From: Eckard, Sharon
Sent: Thursday, July 07, 2016 10:39 AM
To: Liggins, Shirley
Subject: FW: Grubb Management - 500 W. 5th Street Revitalization
Attachments: 14-131345 5 Phase II BF Workplan.pdf

We have reviewed the *Sampling and Analysis Work Plan, 500 West 5th Street & 601 West 4th Street, Winston Salem* (Partner Engineering, May 16, 2016), and I have the following comments, which shouldn't take too long to address:

All – I have just left voice mail messages with Bill and Mike McKenna regarding the Proposal for Phase II Subsurface Investigation, 500 West 5th St & 601 W 4th St., Winston-Salem (Partner Engineering, April 12, 2016). I have reviewed the proposal and have several comments. First as I indicated to Mike last week, Brownfields requires a scope of work in a work plan format that addresses the scope of work, the specific methods that will be undertaken and excludes cost information. With regards to the scope of work it does not fully comport with my email of March 16, 2016 in which I noted the specific types of data we require.

Photo #11

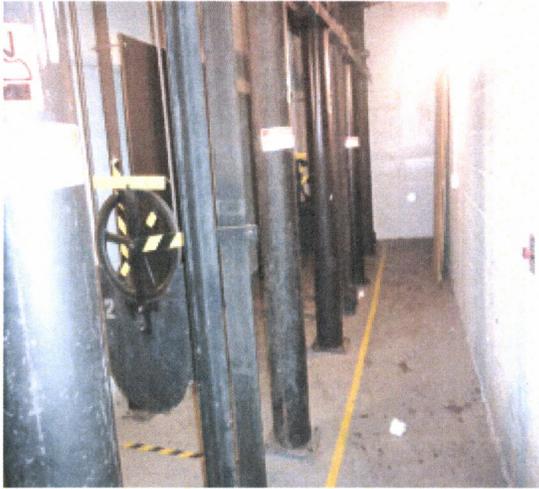
I hope you are well. We are working on putting together a scope of work to address all of your concerns and I wanted to follow-up on the sampling for the elevator pits upon removal of the building(s). All of the elevators associated with the tower buildings are cable driven with no hydraulic elevators. I've included a list of the elevators below along with a couple photos of the elevator pits. Based on the absence of hydraulic pistons in the ground, would their construction remove the need to sample the elevator pits?

Hi Michael – I concur. If the elevators were not driven hydraulically, you do not need to assess below them, unless upon removal you find obvious signs of contamination.
